# APPROVED MINUTES

## March 20, 2026, Standards Committee Meeting

RE: Minutes from the March 20, 2026, Standards Committee Meeting

REVISION TO 2026 STANDARD SPECIFICATIONS and STANDARD DRAWINGS

<b>INDIANA DEPARTMENT OF TRANSPORTATION</b>	
SAWED JOINTS AND JOINT SEALANT SEPTEMBER 2026	
STANDARD DRAWING NO. E 503-CCPJ-02	
	DESIGN STANDARDS ENGINEER _____ DATE _____
	CHIEF ENGINEER _____ DATE _____

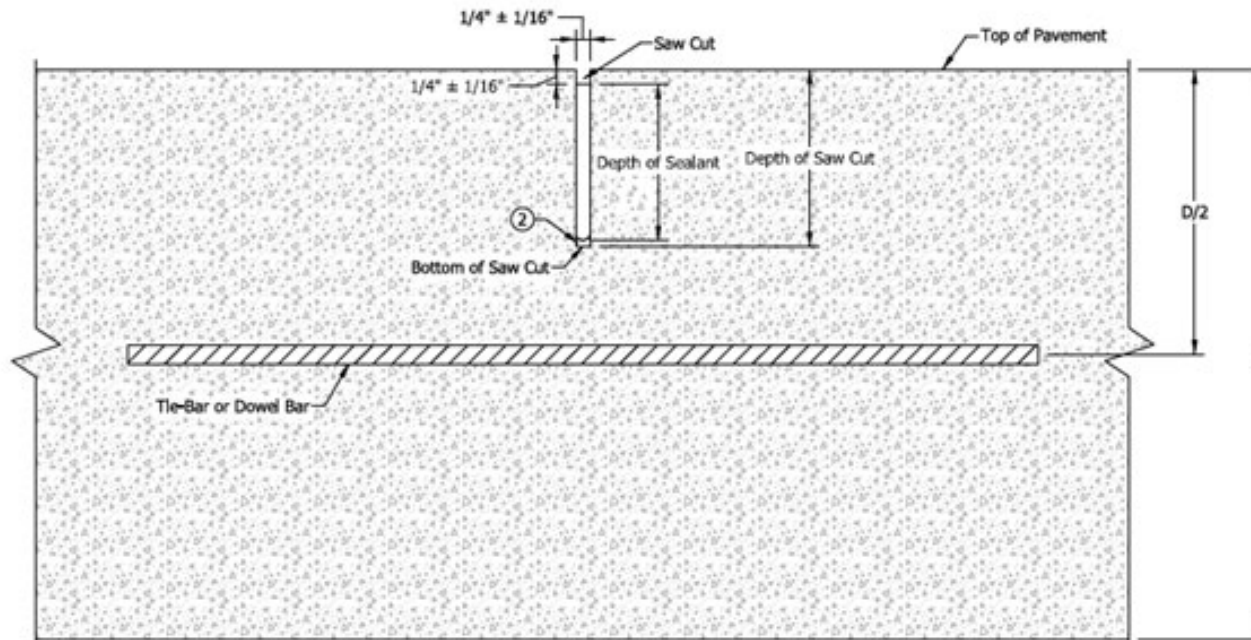
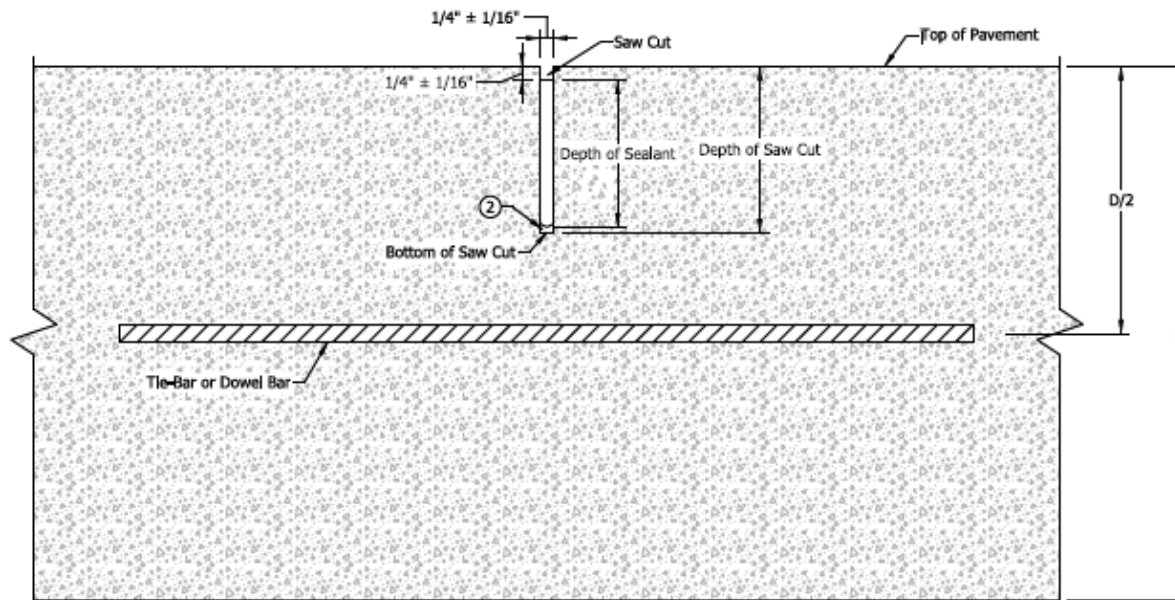
APPLICABLE STANDARD DRAWING: 506-CCPP with corresponding changes to terminology in 503-CCPJ-02

E 506-CCPP-02 JOINT DETAILS (WITH SHOWN MARKUPS)

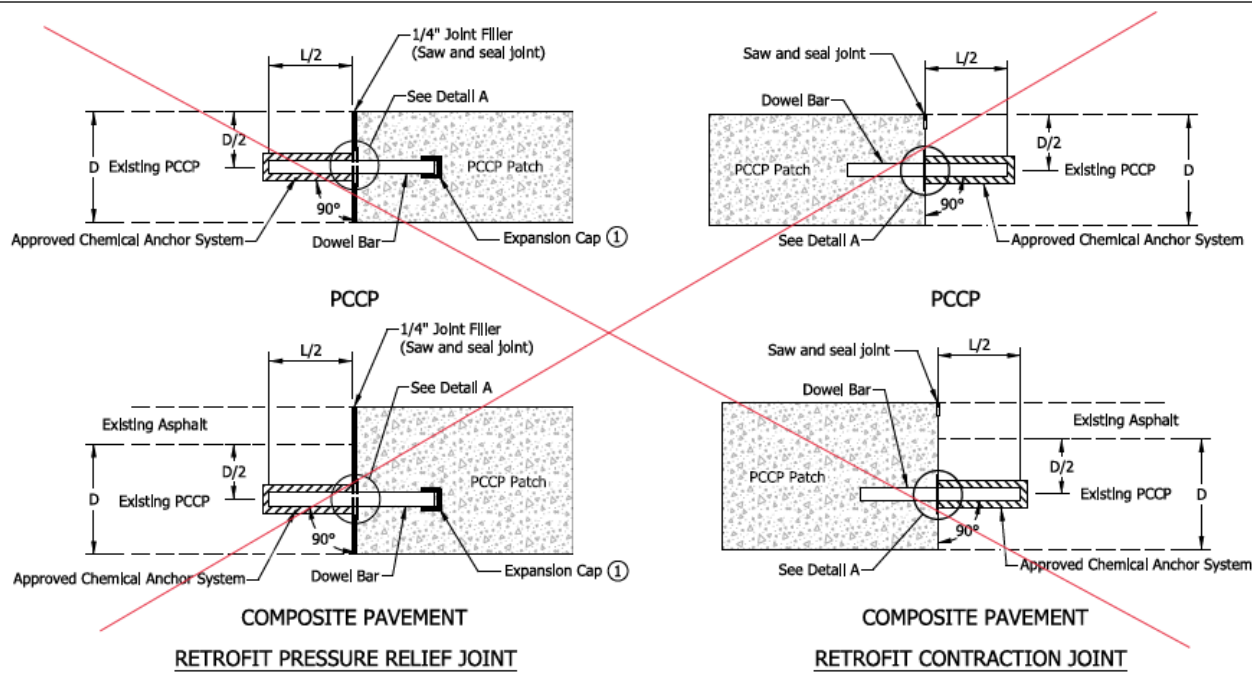
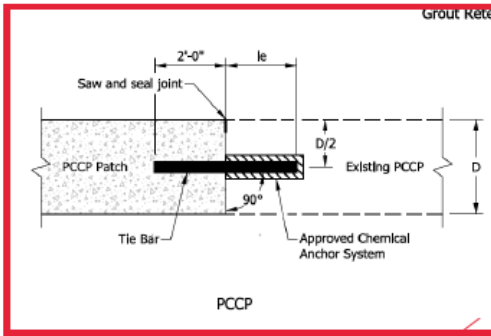
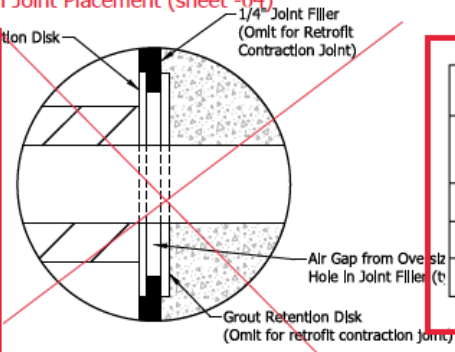
Combine new Retrofit Transverse Joint details with Joint Placement (sheet -04)

add new detail for composite pavement

In reference to drawing 506-CCPP-04, Mr. Koch stated that he is uncertain as to our expectations, usually deformed bars are depicted with hatching. Are we intending smooth or deformed retrofit transverse joint tie bars? Observing the installation of retrofit bars over the years, it is a struggle for a crew to consistently

In reference to drawing 506-CCPP-04 (05 & 06), Mr. Koch suggested that, in order to avoid confusion as deformed bar is preferred at the construction joint, please consider amending the thickness of the depicted tie bar in a manner that differs from d-1 / dowel bars, similar to 503-CCPJ-02.

- Updated hatch of tie bars to align with the 503-CCPJ series.
- Removed hatch of dowel bars to remain consistent with the 503-CCPJ series.
- Added a new saw-cut detail to Sheet -03 to address the potential for diagonal cracking in the lane when a longitudinal saw cut is made at a narrow shoulder. Based on discussions with Nick Cosenza, the cracking risk appears to stem from pouring the lane and shoulder monolithically (16-ft slab). Added new Note 6.
- Revised Sheet -03, Note 1 to allow epoxy in lieu of hot pour, as approved.
- Revised the table on Sheet -04 to specify a minimum 1'-0" embedment (le) for all tie bar sizes.

<b>INDIANA DEPARTMENT OF TRANSPORTATION</b>	
<b>JOINT PLACEMENT</b>	
SEPTEMBER 2020 2026	
STANDARD DRAWING NO. E 506-CCPP-03 04	
	 DESIGN STANDARDS ENGINEER DATE 03/10/20
 CHIEF ENGINEER	DATE 05/01/20

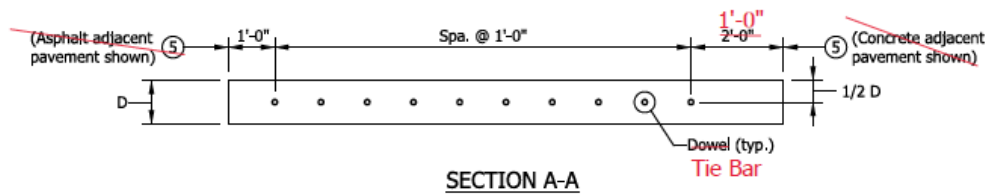
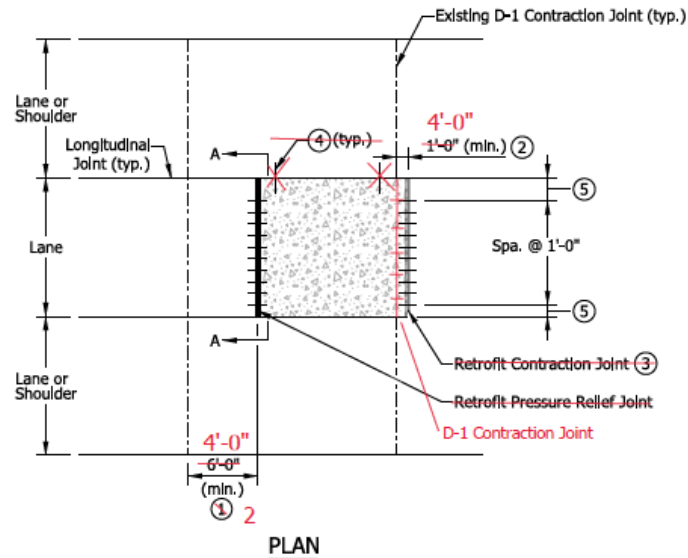
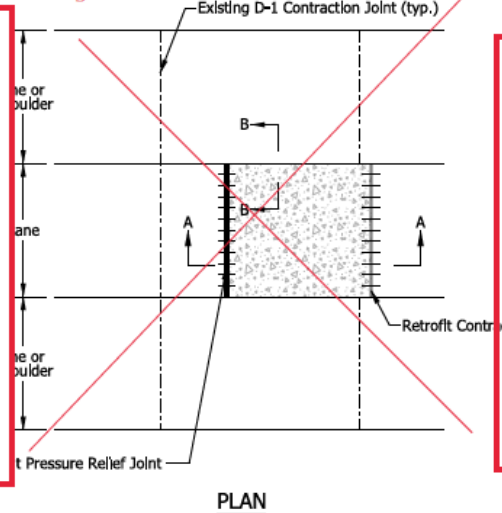
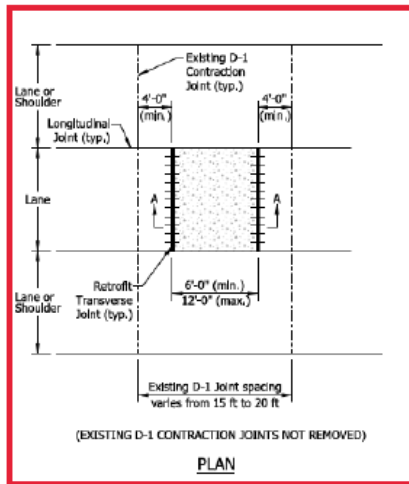
Add new detail for sawcut removal (sheet -03)

Combine these details with new Retrofit Transverse Joint details (sheet -04)

STANDARD DRAWING NO. E 506-CCPP-04 05

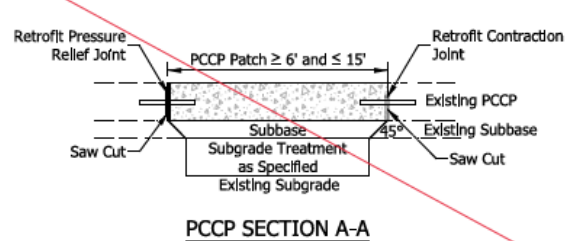
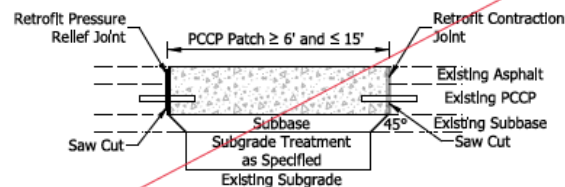
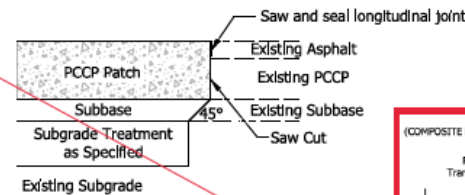
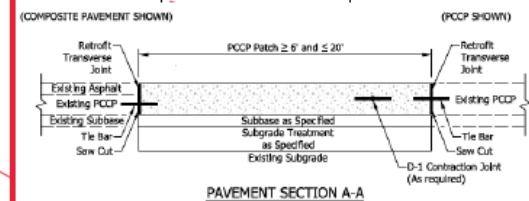
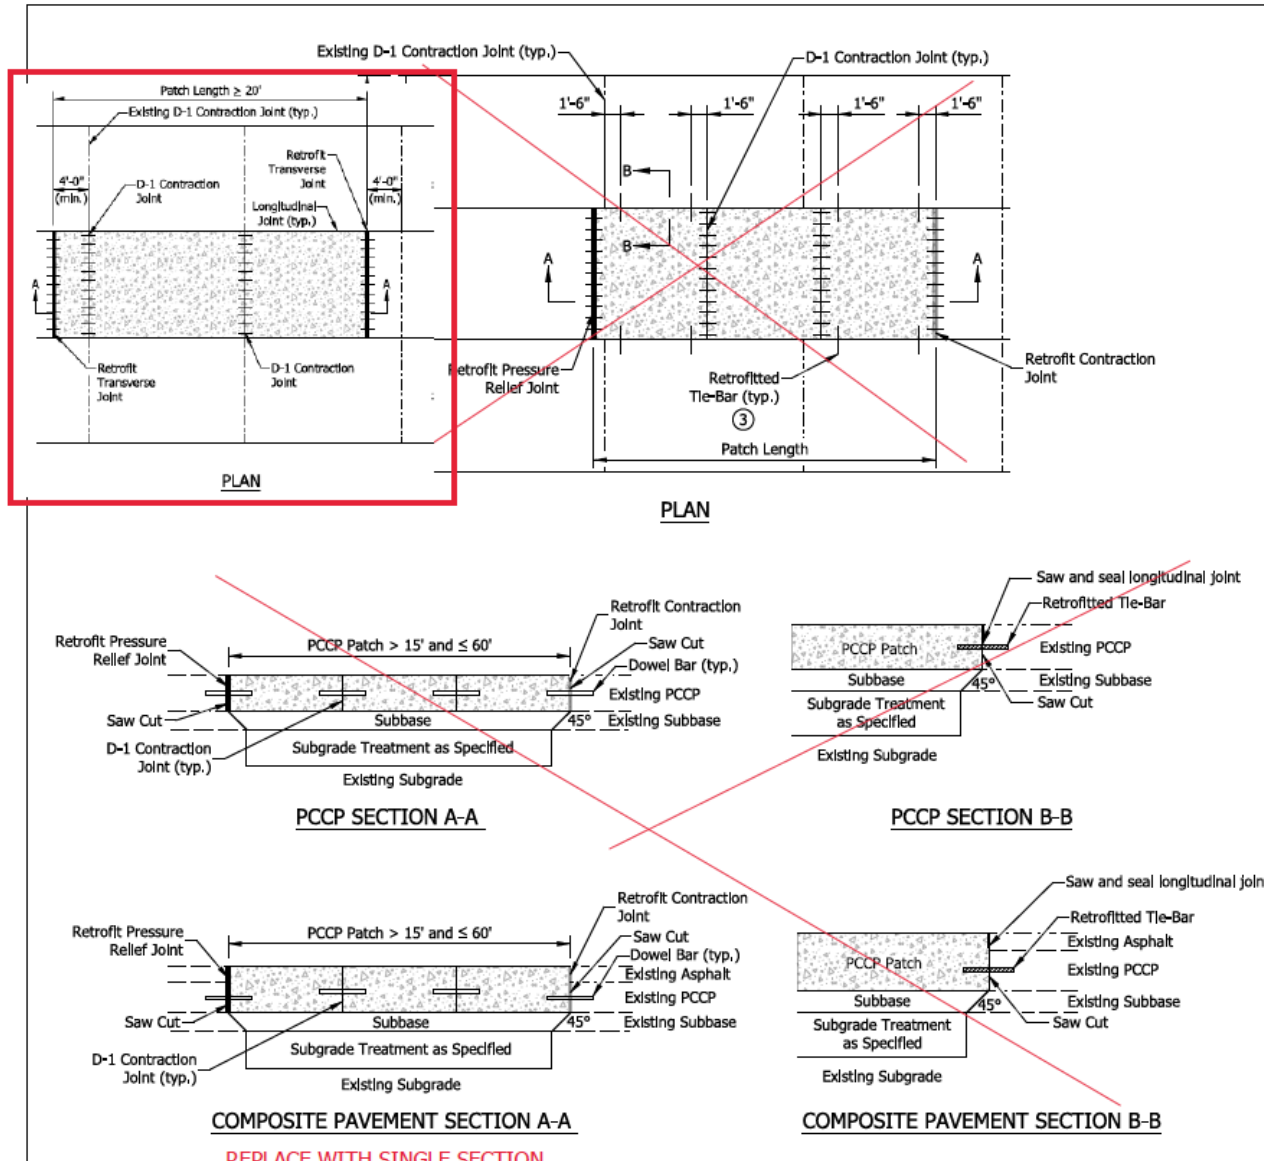
Replace with two details - one between existing D-1, one that removes existing D-1

new notes

REPLACE with a single pavement section

E 506-CCPP-05 PATCH LENGTH (WITH SHOWN MARKUPS)

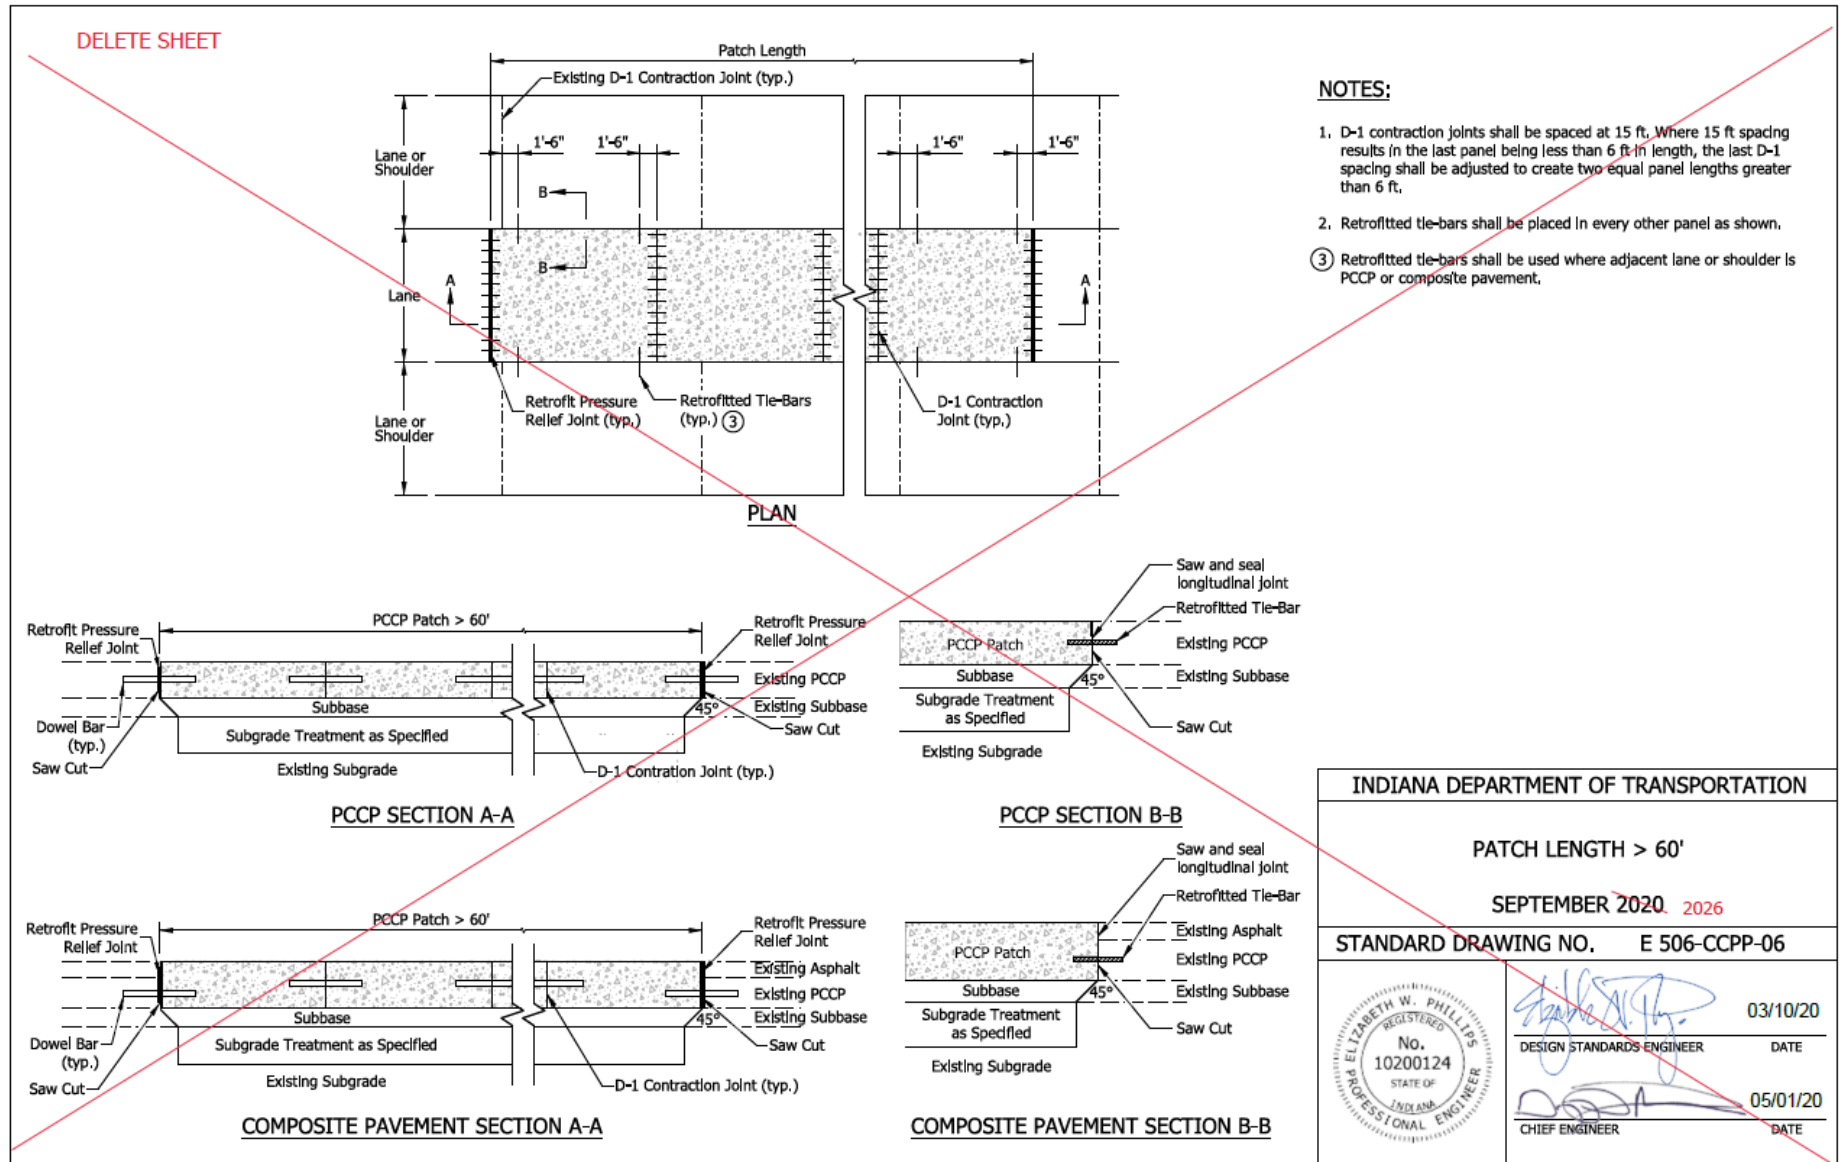
**new notes**

1. D-1 Contraction Joints shall be matched with spacing of the existing D-1 Contraction Joints of adjacent lane or shoulder PCCP.
2. For composite pavement, the PCCP patch D-1 Contraction Joints shall be placed with a maximum spacing of 16 ft, if contraction joints are not apparent in the adjacent lane or shoulder.
3. For a patch length greater than 100 ft, longitudinal retrofitted tie bars shall be required and installed as shown on Standard Drawing E 503-CCPJ-02.
4. See Standard Drawing E 506-CCPP-04 for tie bar spacing.

STANDARD DRAWING NO. E 506-CCPP-07-02

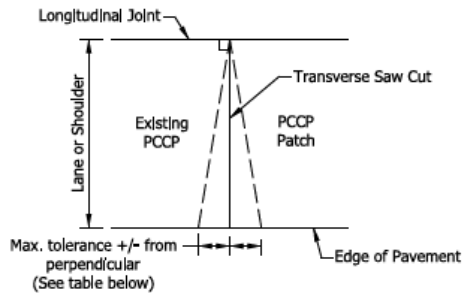
Move contents to Sheet -02

INDIANA DEPARTMENT OF TRANSPORTATION	
SAWCUT REMOVAL DETAILS	
SEPTEMBER 2026	
STANDARD DRAWING NO.	E 506-CCPP-03
DESIGN STANDARDS ENGINEER	DATE
CHIEF ENGINEER	DATE

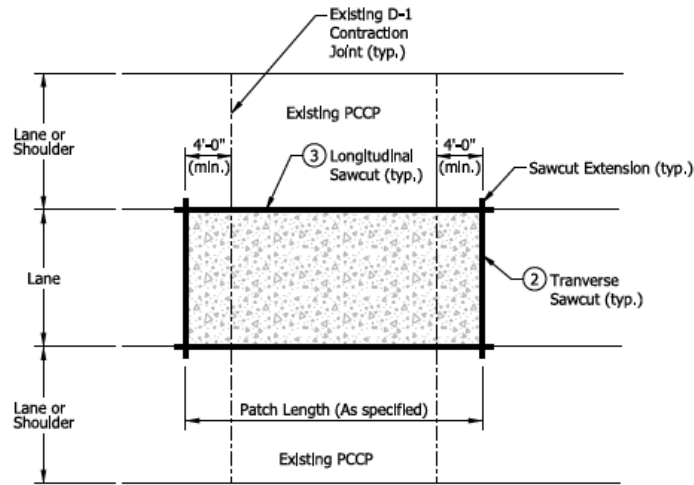
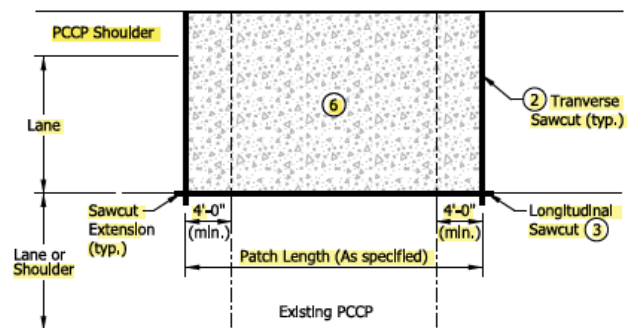
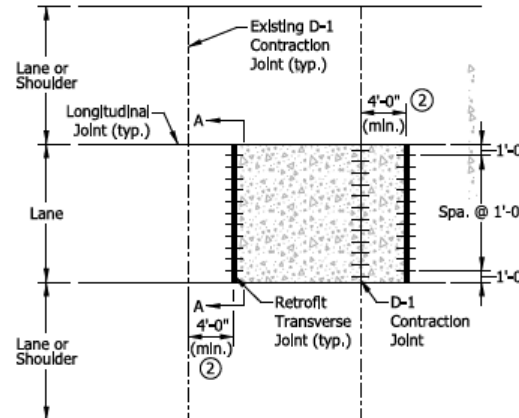
In reference to drawing 506-CCPP-03, Mr. Koch stated that the goal is to cleanly remove the area to be patched without the need for excessive jackhammering to minimize damage and gain efficiency. Mr. Koch also mentioned that 12 in. overcut is not enough in most situations due to the variations in depth of the existing pavement, since 12 in. PCCP is not typically 12 in., and for composite roadways. Please increase the overcut to a max of 2 ft with epoxy filling the cut. Mr. Koch asked to please consider including a note stating that 'The allowable overcutting shall not alter the planned MOT'. Hoping to avoid an inefficiency claim if the MOT only allows for a foot offset.

1. Allow max 16 in. overcut, 18 in. could be ok if we prefer a round number.  
Please do include a plan note stating that the MOT cannot be altered.
2. Fill the overcut with a semi thick epoxy  
Same material as the chemical anchoring system as the material is on hand  
The epoxy will not puddle into the working joint, simple materials could be used to dike the epoxy such as cardboard/thin wood.

Mr. Sipes stated that, regarding the 12 in. max oversaw, the dimension of oversaw needed to fully saw through the existing concrete depending on the depth of the concrete pavement and the diameter of the saw blade being used. I believe the intent is to eliminate damage to the bottom half of the pavement adjoining the patch by saw cutting all the way through the pavement in the corners. The detail and note for the oversawing should allow enough flexibility to determine the length of oversaw required to achieve the goal. In some cases, 12 in. will not be sufficient, which may be one of Mr. Koch's concerns.

Mr. Dave responded that the goal of overcutting is to remove the existing pavement without jackhammering or chipping manually. There seems to be few options as described by Mr. Nantung. However, in reality, the contractor will not change the blade or use vertical saw to remove the existing pavement for the patching. Though the 12 in. overcut will be ok for most of the pavement, we can increase overcutting to max 14 in. or 16 in. to cover thicker pavement if everyone agrees. We don't want to initiate cracks beyond overcutting.

INDIANA DEPARTMENT OF TRANSPORTATION	
RETROFIT TRANSVERSE JOINT DETAILS	
SEPTEMBER 2026	
STANDARD DRAWING NO. E 506-CCPP-04	
DESIGN STANDARDS ENGINEER	DATE
CHIEF ENGINEER	DATE

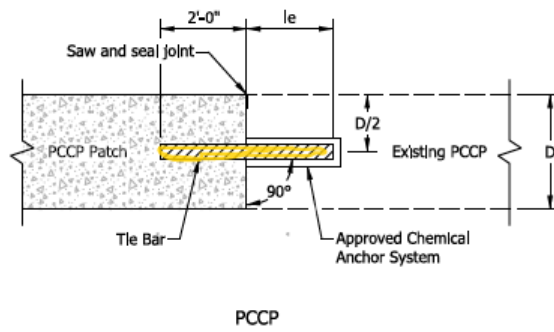
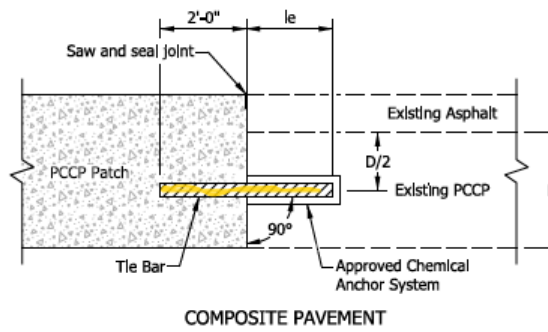
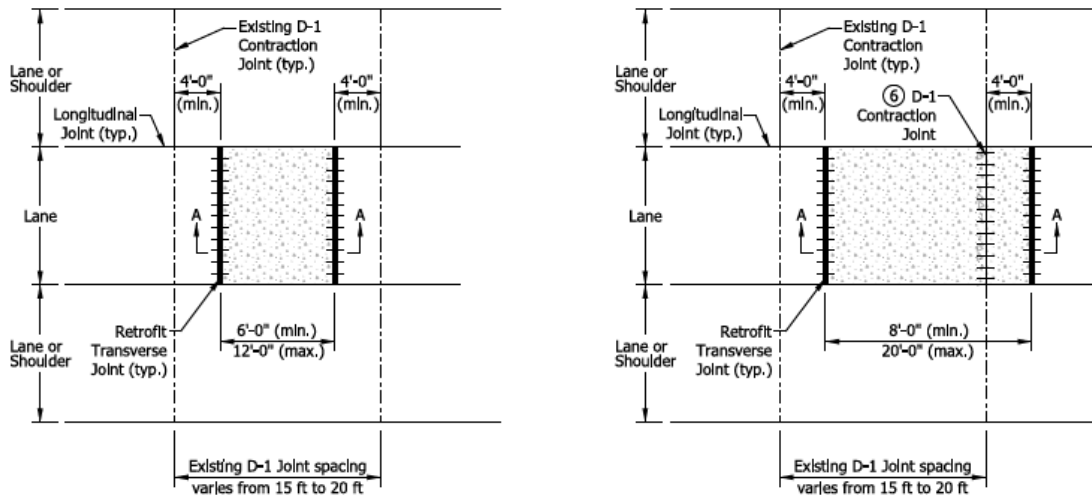
glue the bars into the correct plane. I tend to believe/assume most retrofit joints will be locked due to out of plane bars. Mr. Dave agreed and stated that the dowels bars shall be deformed, as stated above.
